Re: UNM Gibson Commercial Development Drainage Management Plan, ZAP L-16
Engineer's Stamp Dated 9-14-11

Re: UNM Gibson Commercial District Drainage Management Plan and Conceptual Grading Plan
Engineer's Stamp dated 10-28-11 (L15/D006)

Re: UNM Gibson Commercial District Drainage Management Plan and Conceptual Grading Plan

Re: UNM Gibson Commercial District Drainage Management Plan
Engineer's Stamp dated 9-14-11 (L15/D006)

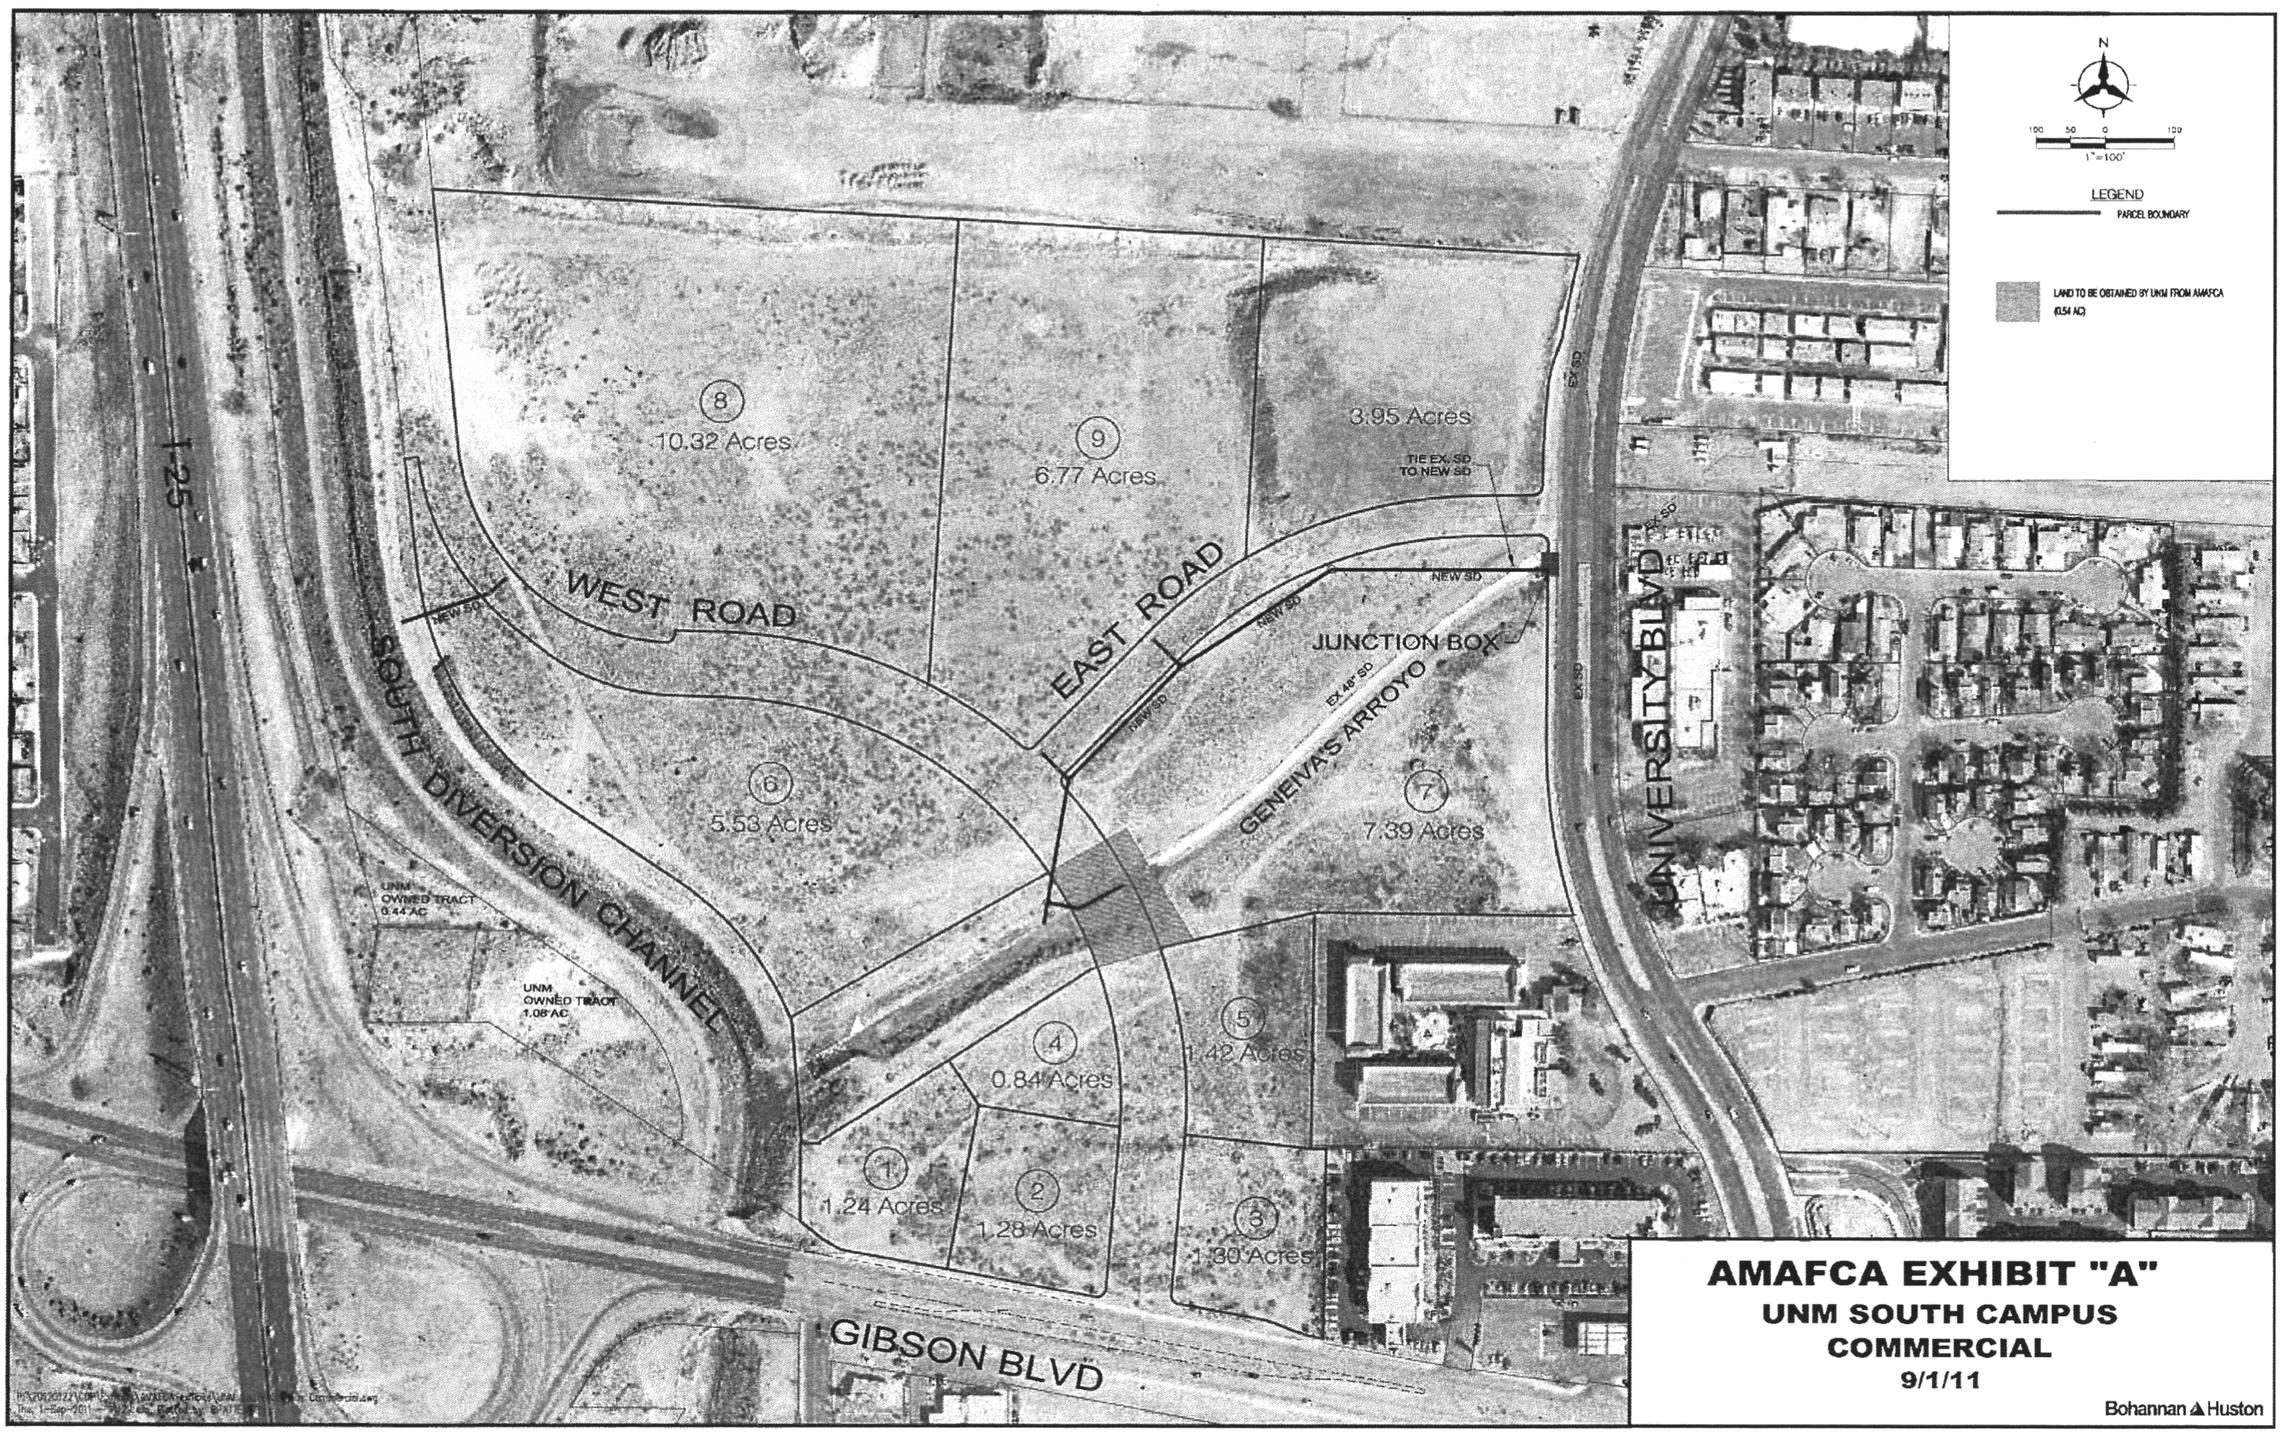
1. They are seriously considering extending the pipe outfall to the South Diversion Channel (SDC). The arroyo property will remain AMAFCA R/W until some future date when we can declare it surplus. We may consider leasing it in the interim.

2. The second pipe outfall to the SDC has been eliminated. They were able to take the flow to the proposed outfall south of Sunshine Terrace.
3. For the upcoming platting action, we discussed dedicating roadway R/W to the City for the portion of West Road in AMAFCA R/W (see the green area on the attached exhibit). AMAFCA will retain a drainage easement.

4. The remaining green area to the east of West Road will be swapped for a portion of access R/W or easement from UNM to AMAFCA for access from Gibson to the SDC.
